UNTIL SUCH TIME AS THESE DRAWINGS ARE APPROVED BY THE APPROPRIATE REVIEWING AGENCIES, OR ENGINEERING APPROVES THEIR USES DESIGNATED BY WRITTEN AUTHORIZATION.	
PREPARED FOR	ROI PROPERTY GROUP, LLC 2495 RIGDON STREET NAPA, CALIFORNIA (707) 365-6891 BRADY WILLIAMS
	 J.R. ENGINEERING A Westman Company Centennial 303-740-9888 • Colorado Springs 719-583-2583 Fort Collins 970-491-9888 • www.jrengineering.com
BY	DATE
No.	REVISION
H-SCALE	1"=200'
V-SCALE	N/A
DATE	1/2/21
DESIGNED BY	AHC
DRAWN BY	AHC
CHECKED BY	
SADDLEHORN RANCH - FILING 2	
HORIZONTAL CONTROL PLAN	
SHEET	5 OF 40
JOB NO.	25142.04

SADDLEHORN RANCH -
 FILING 2
 STREET IMPROVEMENT PLAN
 AND PROFILE

**CL- EL RAICENO PLACE PROFILE
 STA 100+00.00 TO 108+00.00**

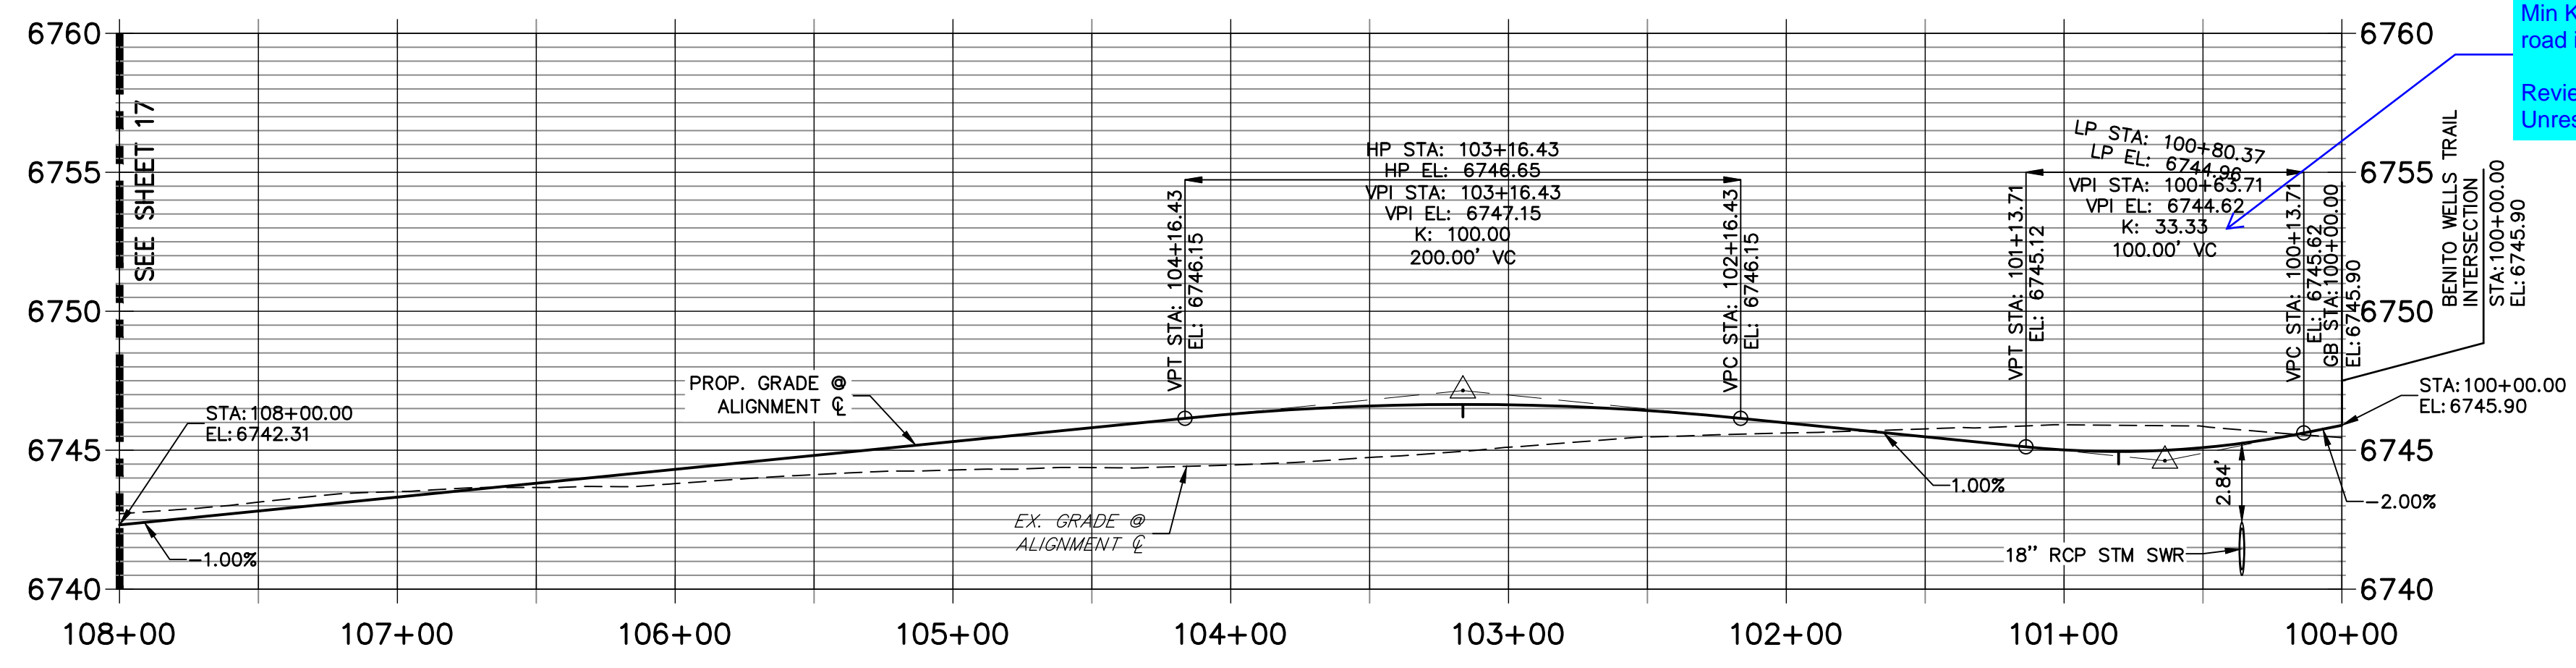
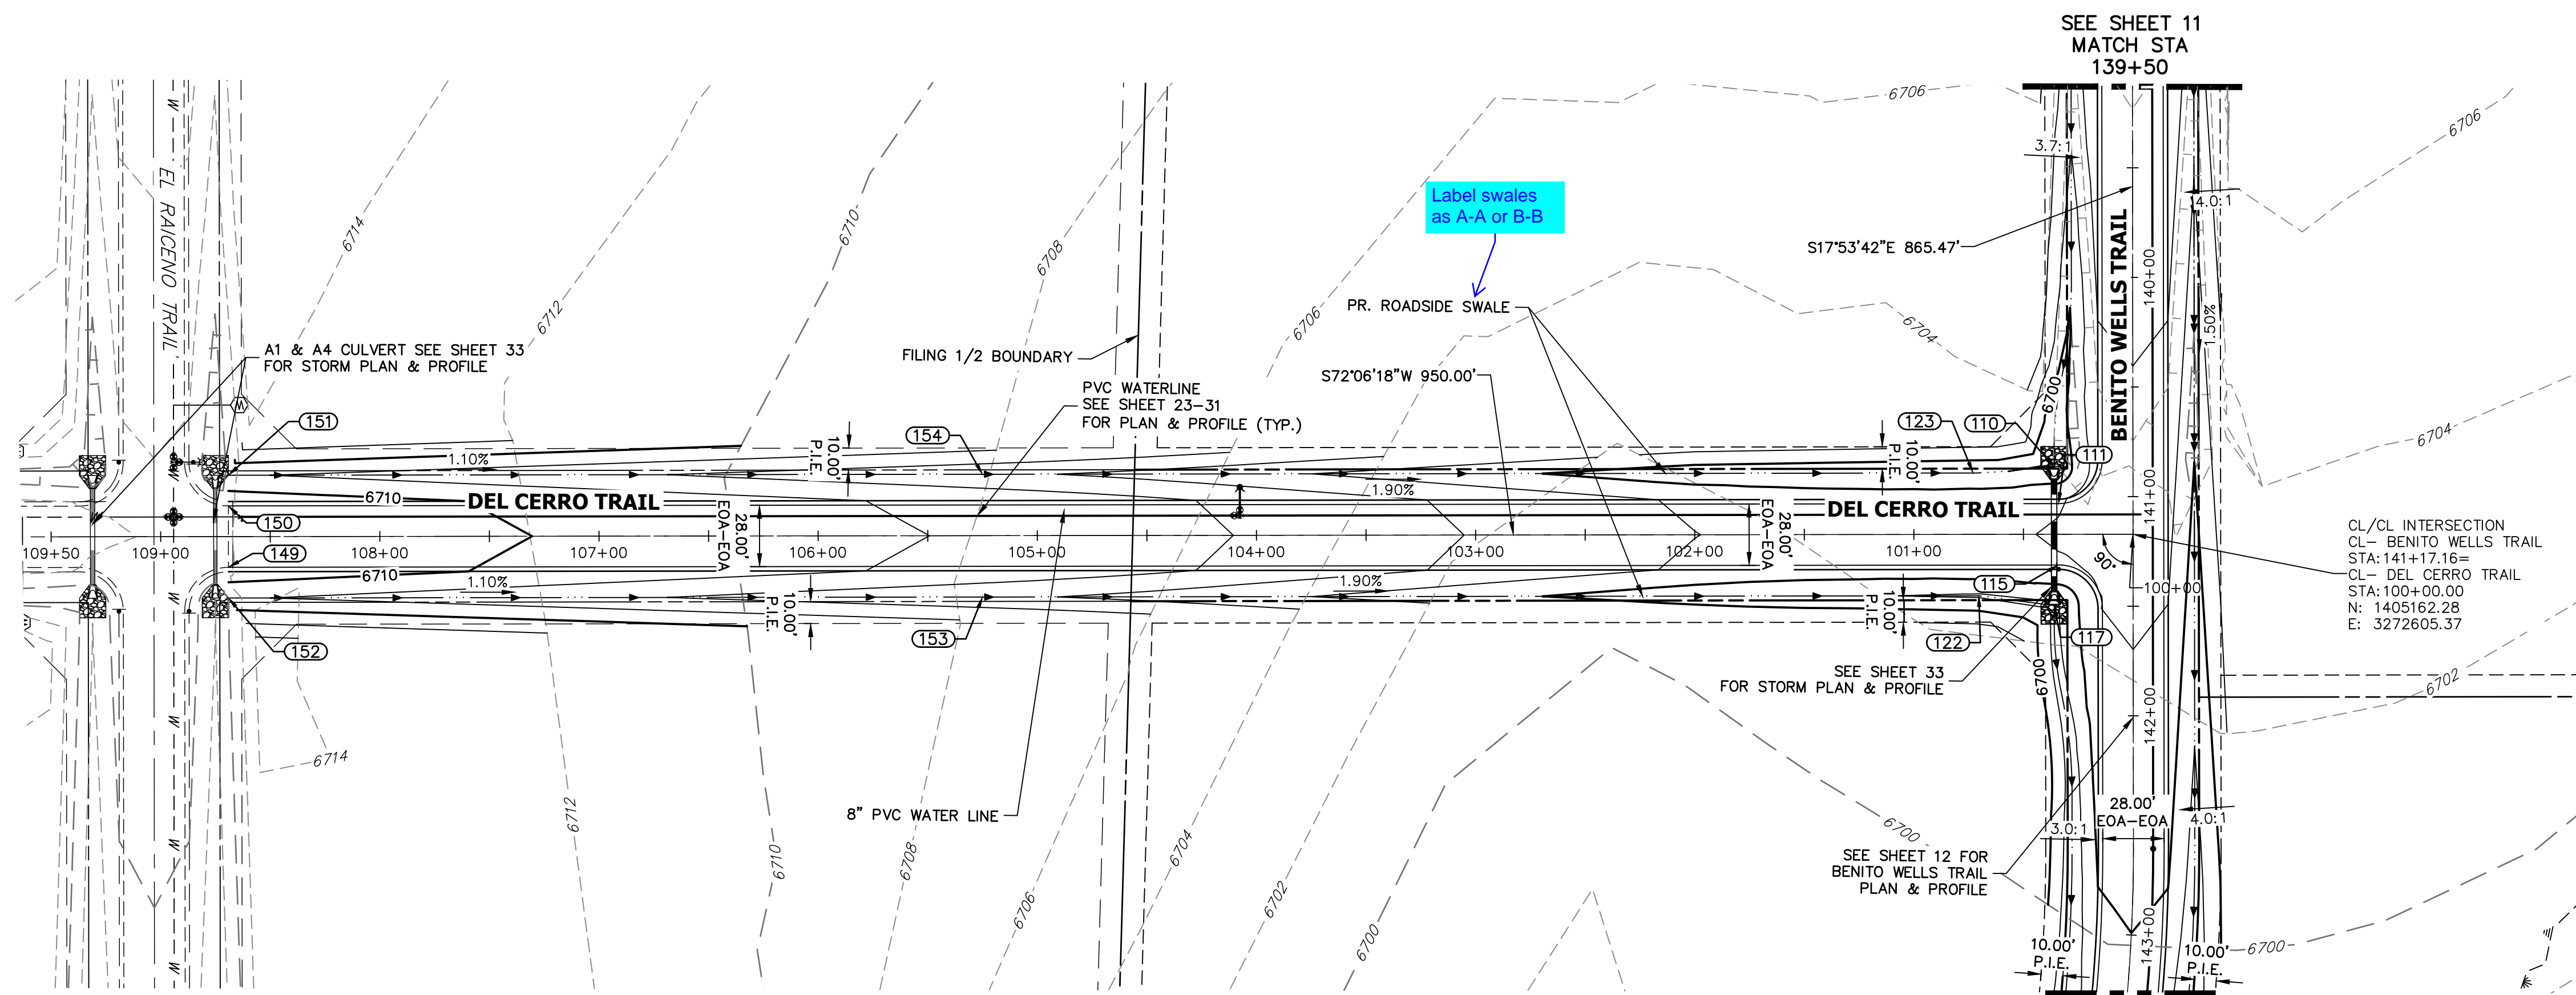
Review 1:
 Min K-value for 30 mph rural road is 37 & fix text rotation

Review 2:
 Unresolved

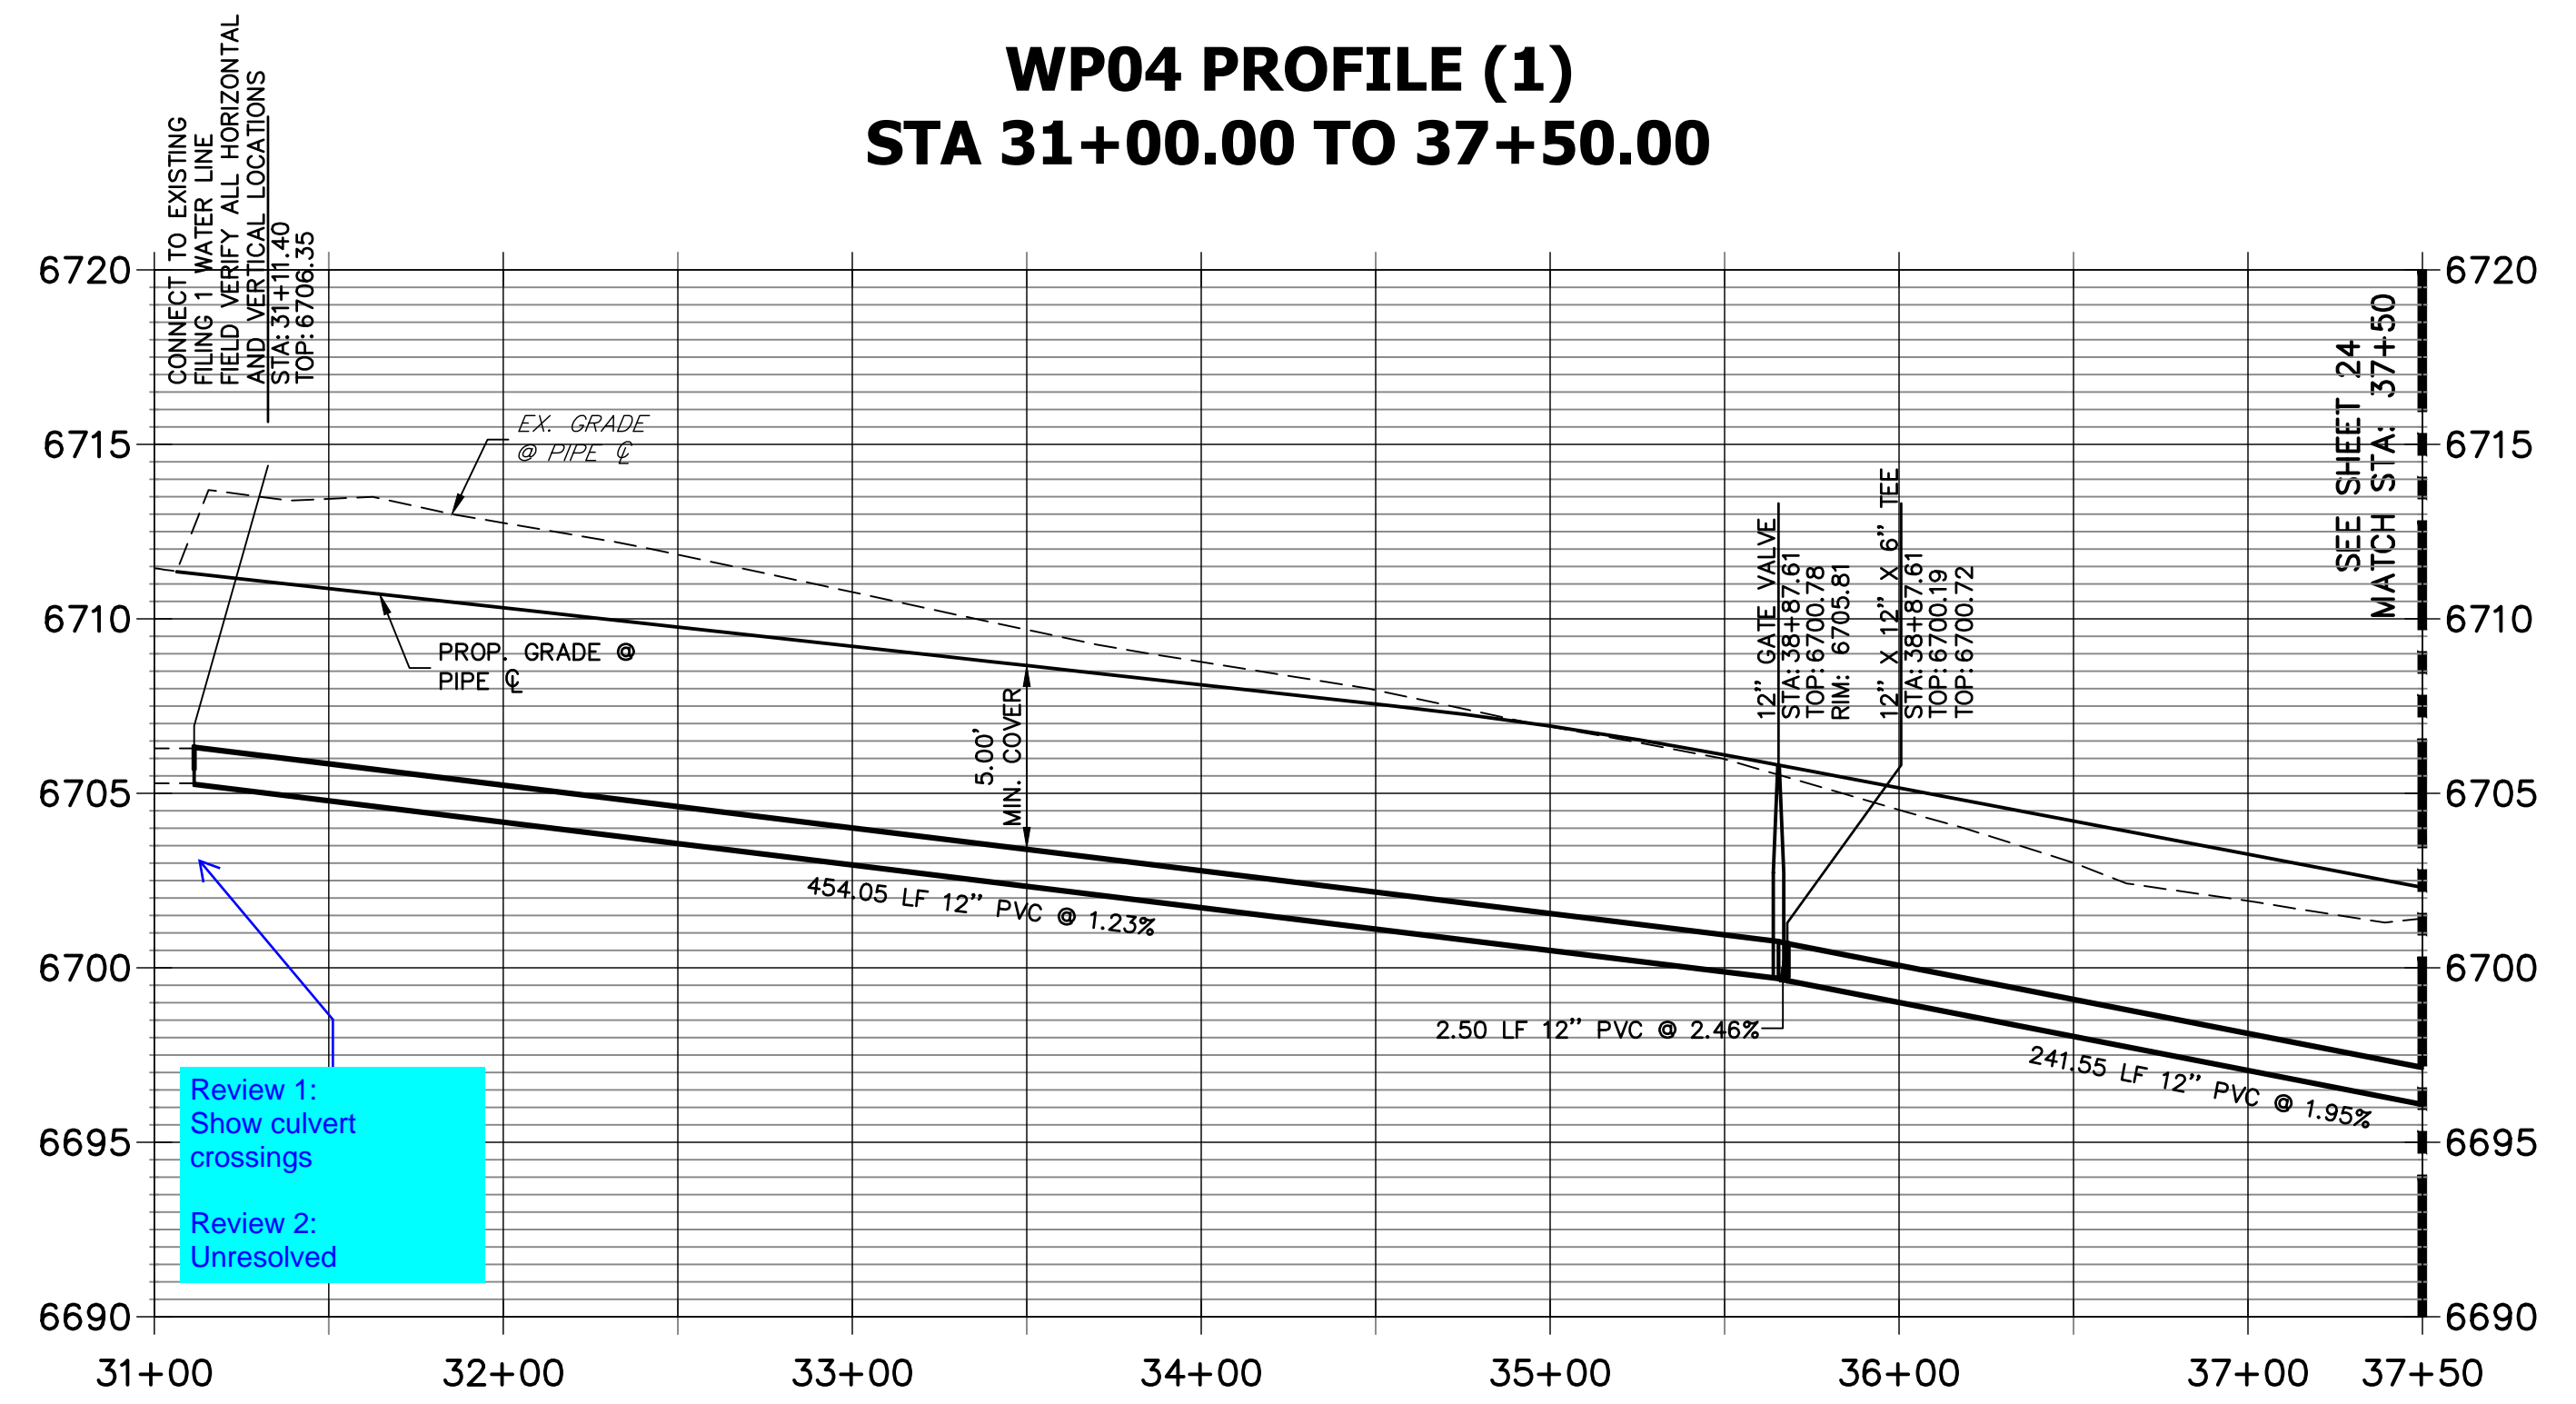
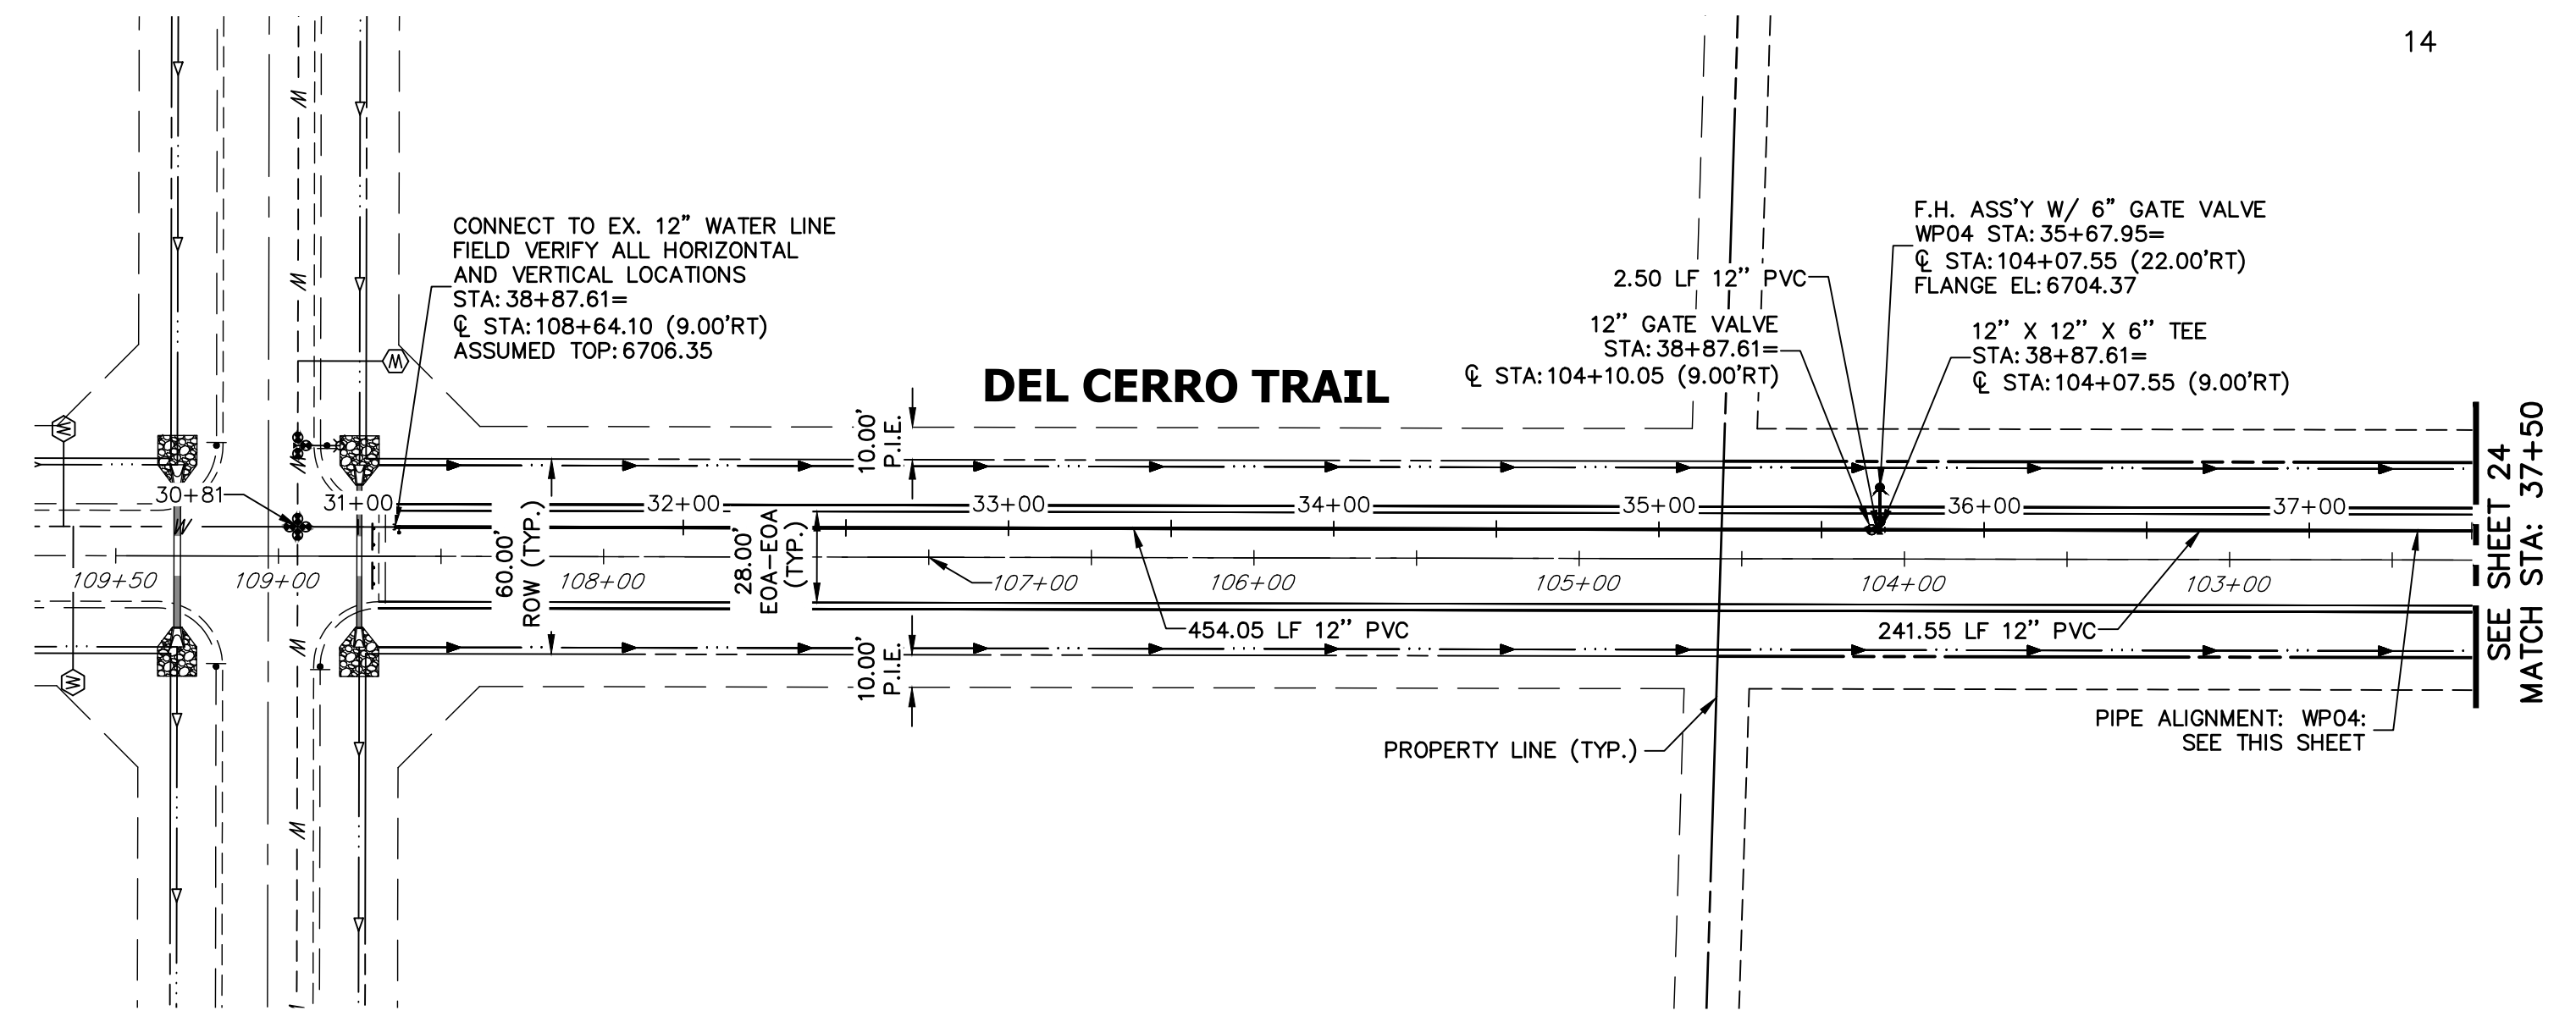
Review 1:
Show culvert crossings

Review 2:
Unresolved
